Origination Form
Proposed Revisions to a Standard Plans Index

Originator:	Turley, Joshua	Index Number:	102-200
Date:	5/15/2025	Sheet Number(s):	All sheets
E-mail:	Joshua.Turley@dot.state.fl.us	Index Title:	TEMPORARY ACROW 300 SERIES DETOUR BRIDGE GENERAL NOTES AND DETAILS

ELEVATION VIEW
 (TIMBER PILES SHOWN, STEEL H PILES AND STEEL PIPE PILES SIMILAR)
 (Thrie-Beam Panel not shown for clarity, See Index 102-240)

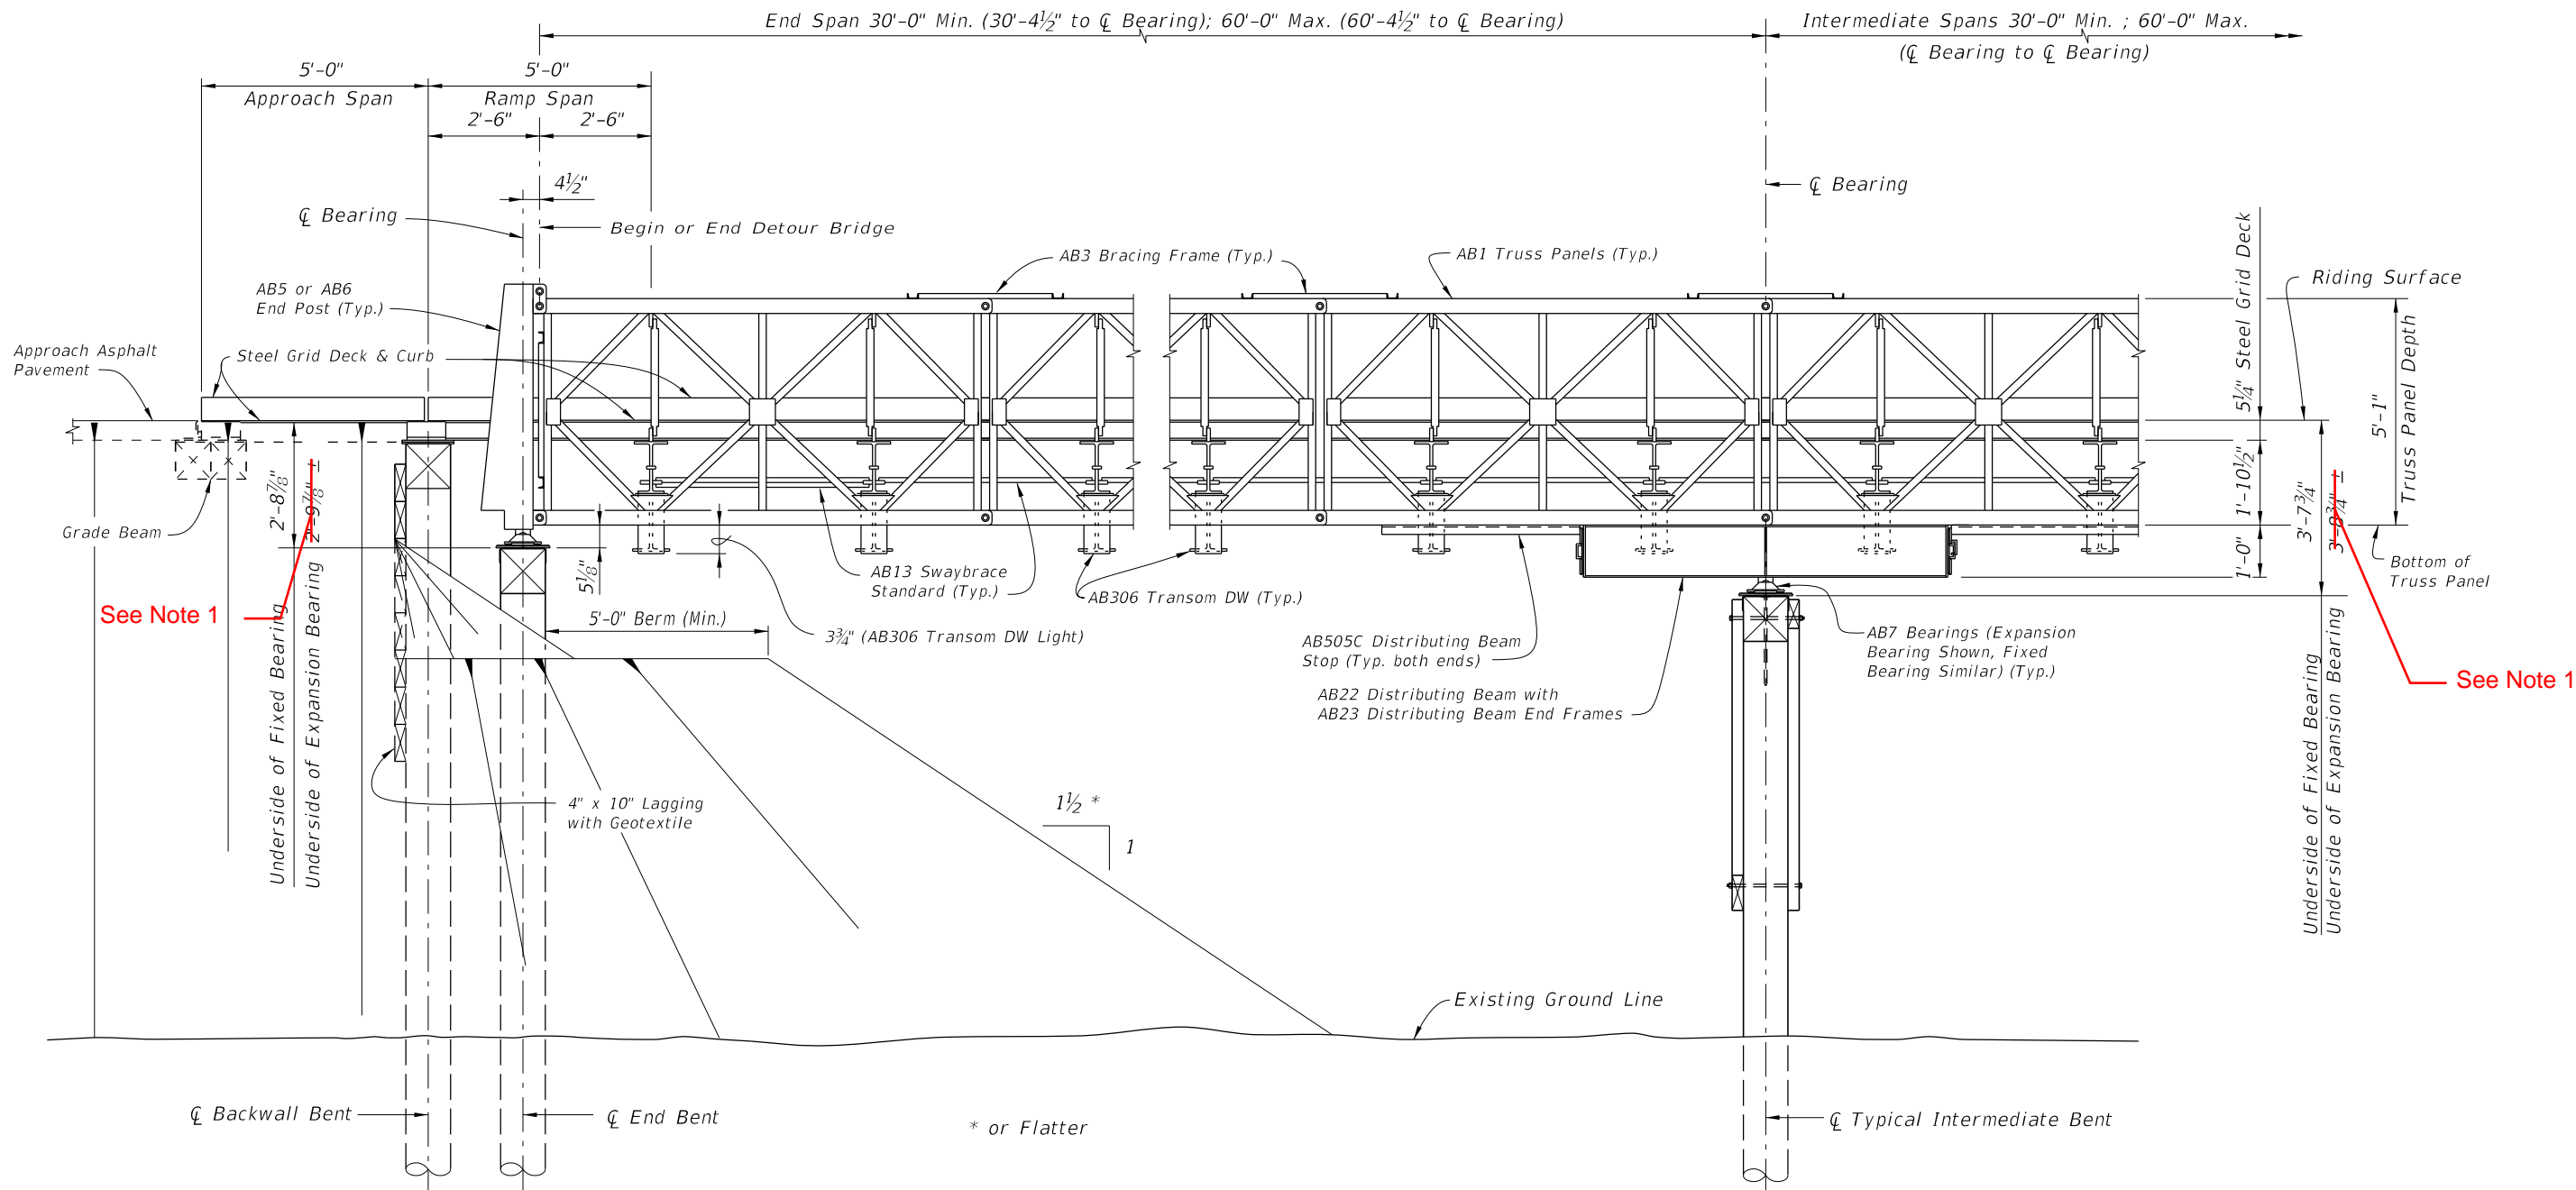
Sheet 1: Changed number of sheets
 Sheet 2: Changed number of sheets
 Sheet 3: Removed underside of expansion bearing dimension and added a note that it will be set in final design.
 Sheet4: Removed the note that indicated FDOT will provide both the expansion and fixed bearings and changed it to just the ACROW AB7 bearing and added a sheet reference to it.
 Sheet 5: Removed sheet
 Sheet 6: Changed number of sheets
 Sheet 7(NEW): Added an expanded set of details for the intermediate bearings instead of the abbreviated details on the old Sheet 5.
 Sheet 8(NEW): Added an expanded set of details for the end bent bearings instead of the abbreviated details on the old Sheet 5.

Sheet 3: We dont actually know the underside dimension for the bearings until final design so it is inappropriate to ball park the dimension.
 Sheet4: We are being more specific about what FDOT does and does not provide to the Contractor.
 Sheet 5: Deleted sheet and added information with expanded details for clarity on new Sheets 7 and 8.
 Sheet 7: Expanded details of the bearings add clarity.
 Sheet 8: Expanded details of the bearings add clarity.

NOTES:
 1. The dimension to be determined based on final design of substructure. Expansion bearings designed & detailed by Specialty Engineer and supplied by Contractor.

DETAILS FOR FDOT SUPPLIED FIXED BEARINGS

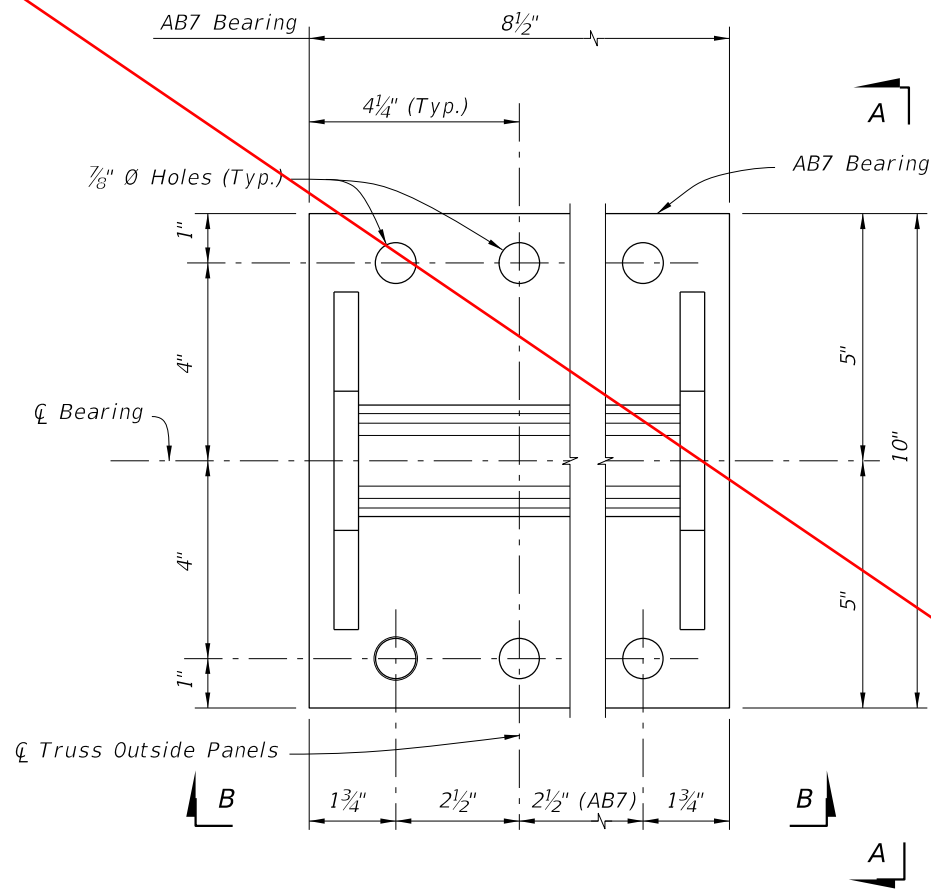
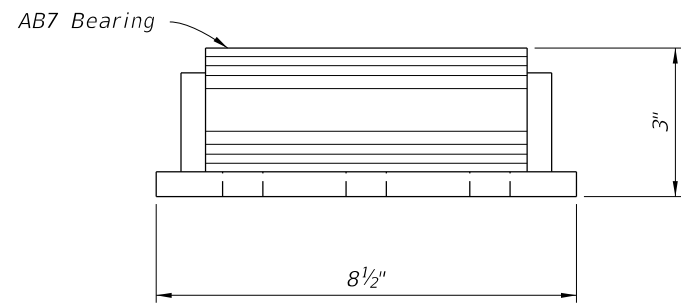
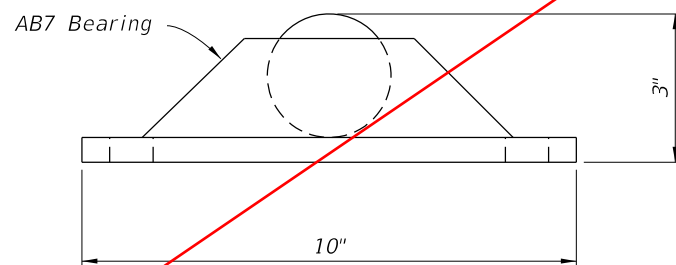
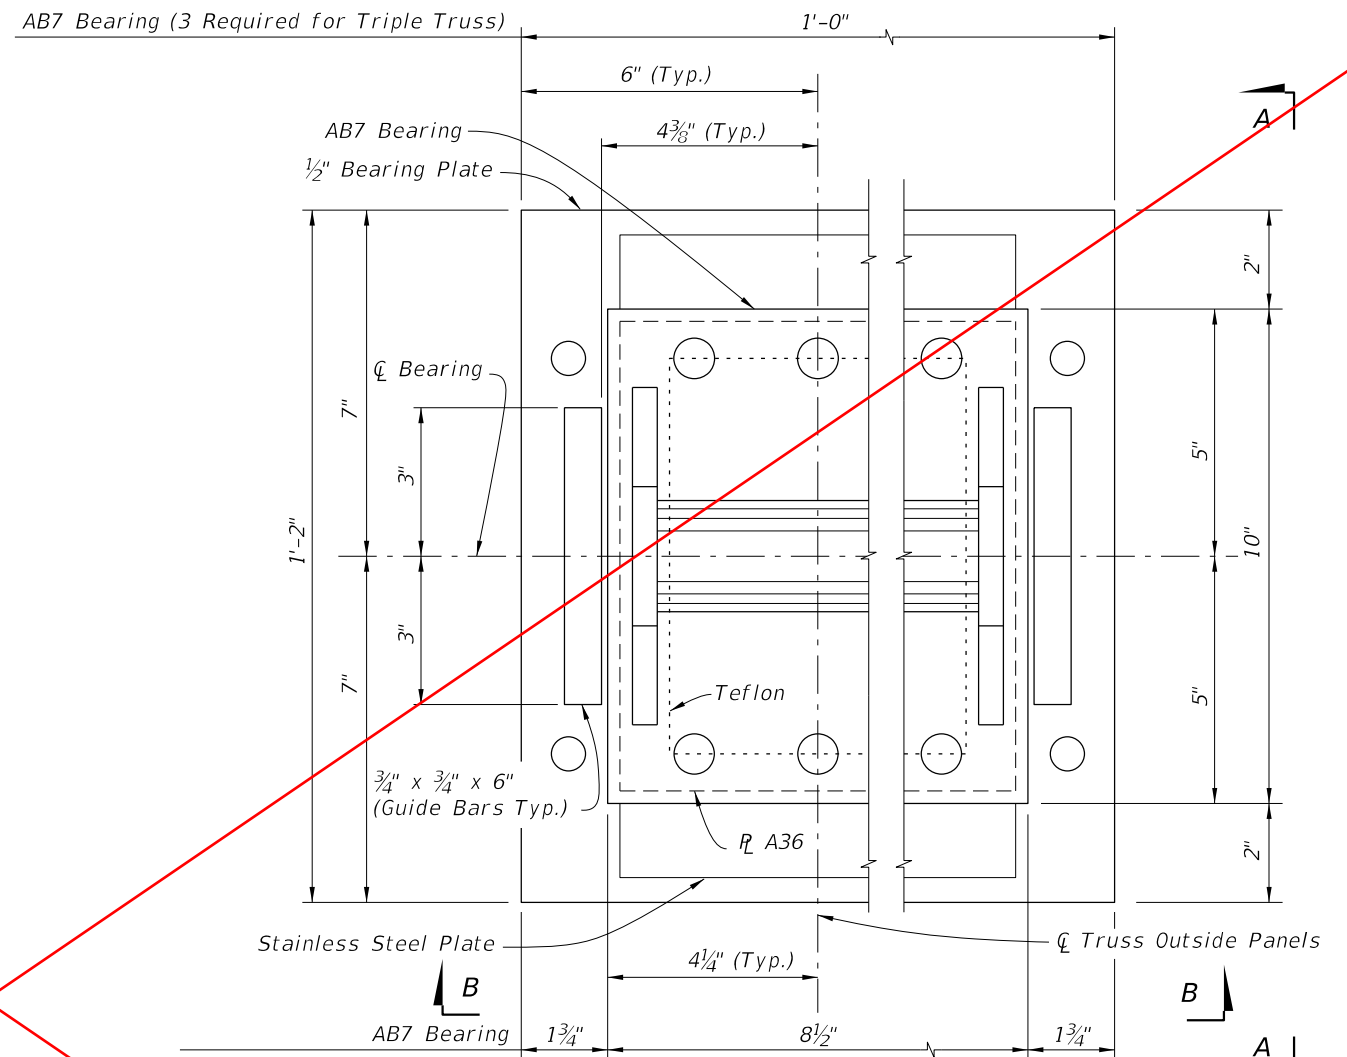
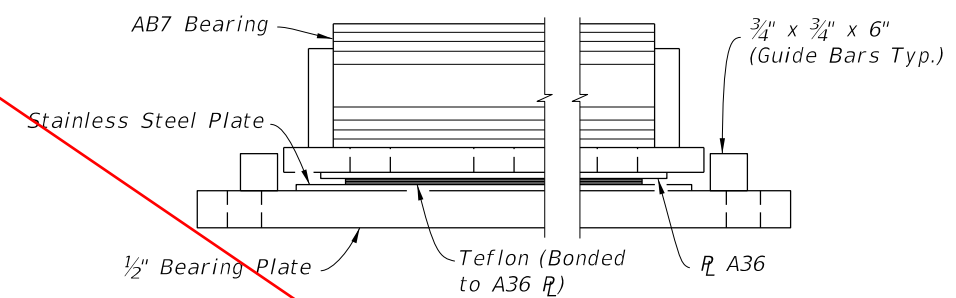
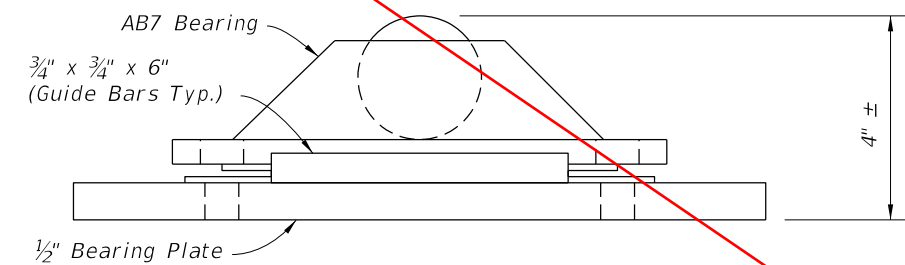
Remove Sheet

LAST REVISION 11/01/25	REVISION	DESCRIPTION:	 FY 2026-27 STANDARD PLANS	FIXED BEARING DETAILS AT INTERMEDIATE BENT	INDEX 102-200	SHEET 7 of 8
------------------------------	----------	--------------	---	---	------------------	-----------------

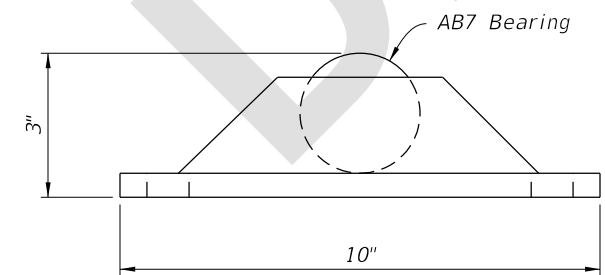
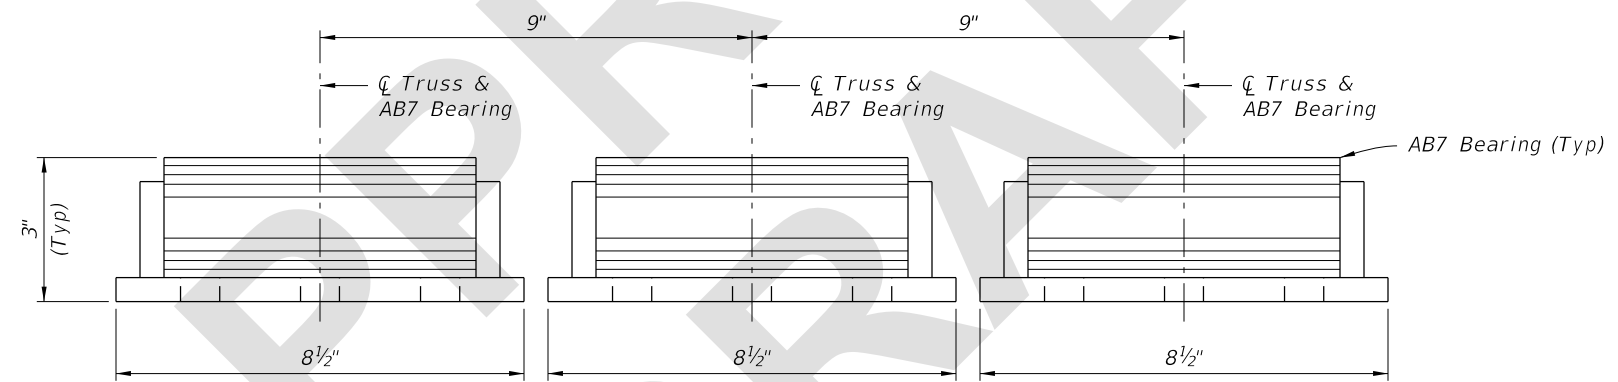
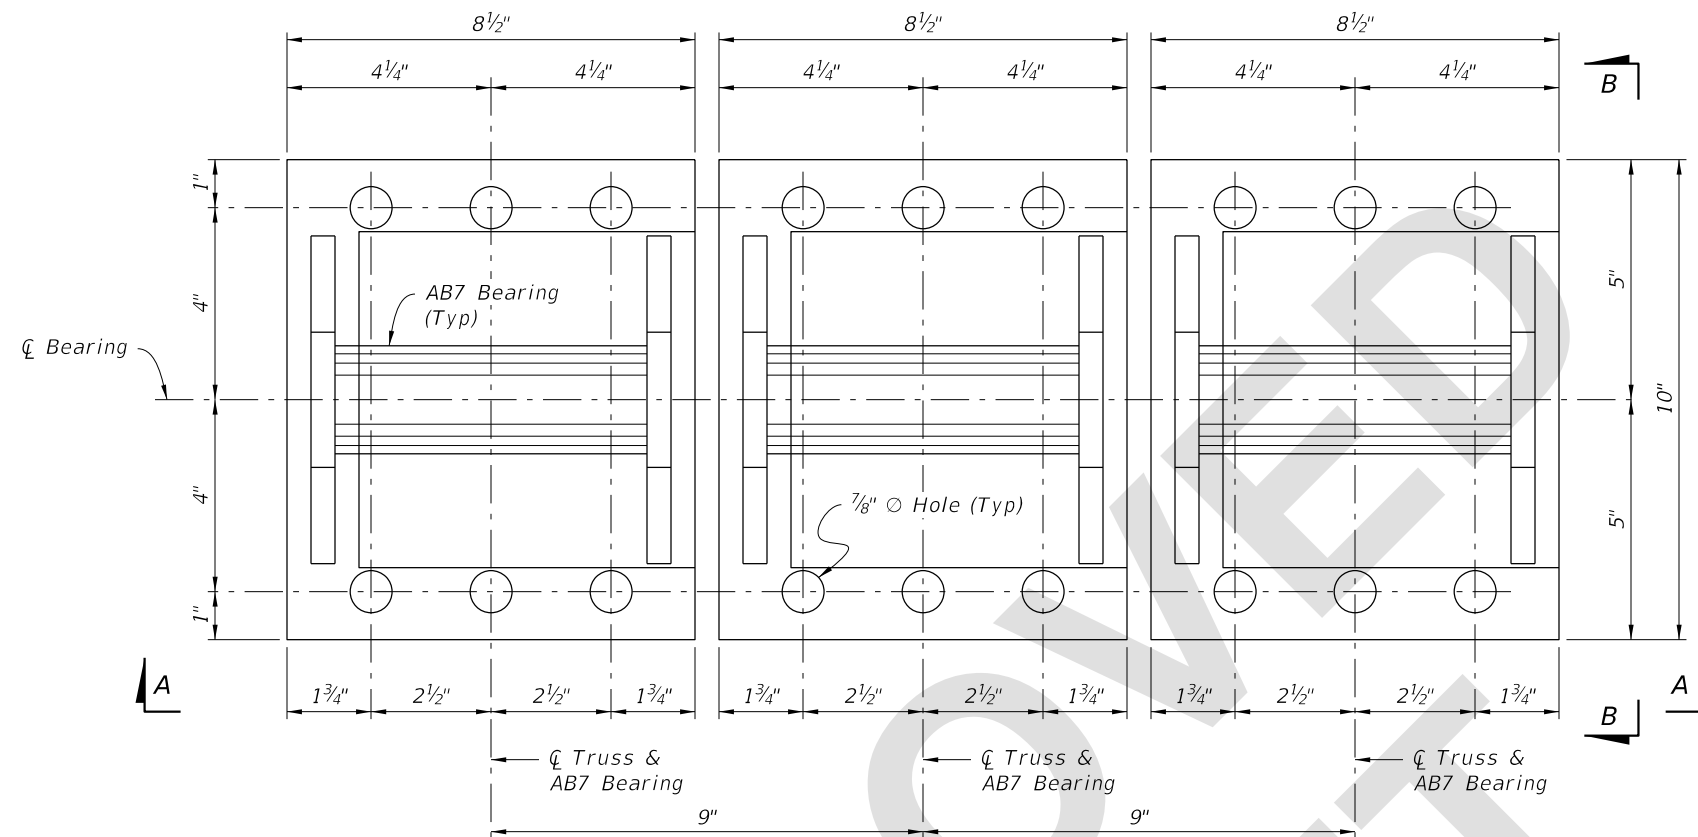
**NEW SHEET 7: Details for
Intermediate Bearings**
